Sequoyah Nuclear Plant, Unit 2
Facility Operating License No. DPR-79
NRC Docket No. 50-328

Subject: Application for Temporary Change to Technical Specifications to Allow Use of Penetrations in Shield Building Dome During Modes 1 through 4; and Request for Specific Usage of Alternate Source Term Methodology for Calculating Radiation Doses Associated with the Proposed Temporary Change to Technical Specifications (TS-SQN-2011-03)

TENNESSEE VALLEY AUTHORITY SEQUOYAH NUCLEAR PLANT UNIT 2

EVALUATION OF PROPOSED CHANGE

Figure 2: STP Model

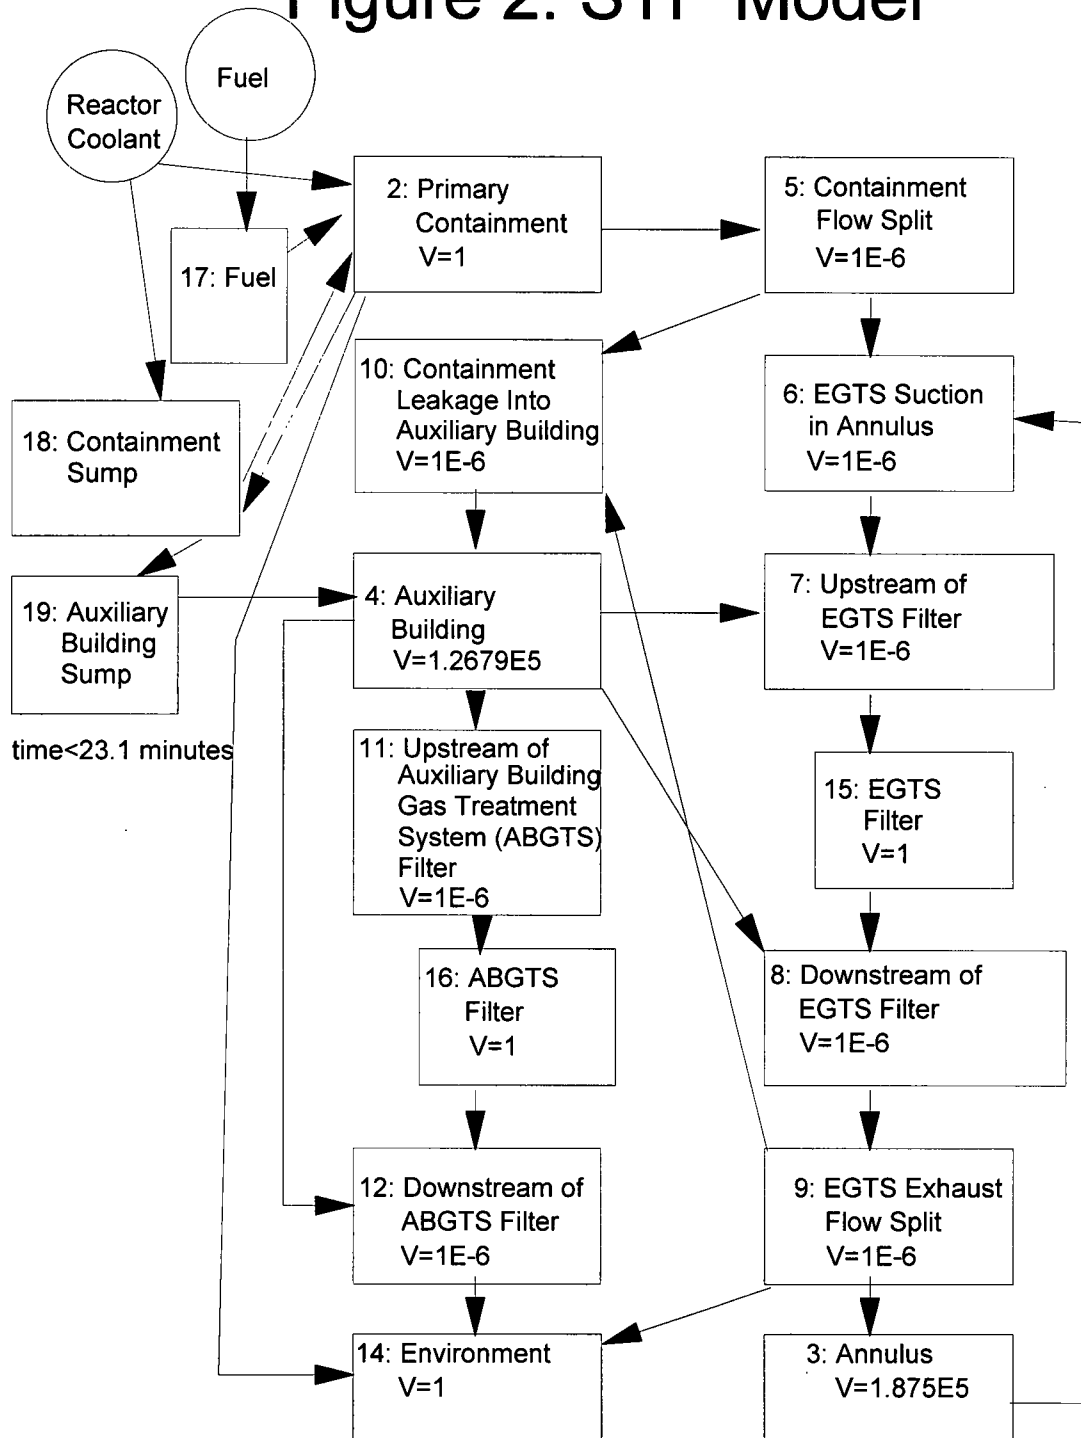
of the open Shield Building dome penetration hatch (22.1 minutes) and reestablishment of annulus negative pressure (1 minute) at 23.1 minutes into the accident was modeled by taking the calculation zero differential pressure case and adding 23.1 minutes to all times following the time the annulus reaches its maximum post-accident pressure. Additionally, a bounding single failure, i.e., a failure of the pressure control operator (PCO), is assumed that results in the greatest steady state EGTS flow being exhausted to the environment until one train is shut down by Operations at 2 hours into the LOCA event. At this point, the train that is selected is assumed to have a PCO failure. The model results of EGTS flows versus time (Figure 1) were then used in the Source Transport Program (STP) computer code model from the dose calculation to determine the radiological releases. The STP model (Figure 2) was modified as follows:

1. The EGTS exhaust flows (flow from 9 to 14 on Figure 2) as shown in Table 1 and Figure 1.
2. EGTS recirculation flows (flow from 9 to 3 on Figure 2) as shown in Table 1 and Figure 1.
3. For times less than 23.1 minutes, the flow from containment to the annulus (flow from 2 to 5 on Figure 2) is zero, since this flow (1.74×10^{-6} cfm) is redirected to the environment (flow from 2 to 14 on Figure 2).

(Note: Model components 1 and 13 are not used in the current revision of the model and are not depicted in Figure 2.)
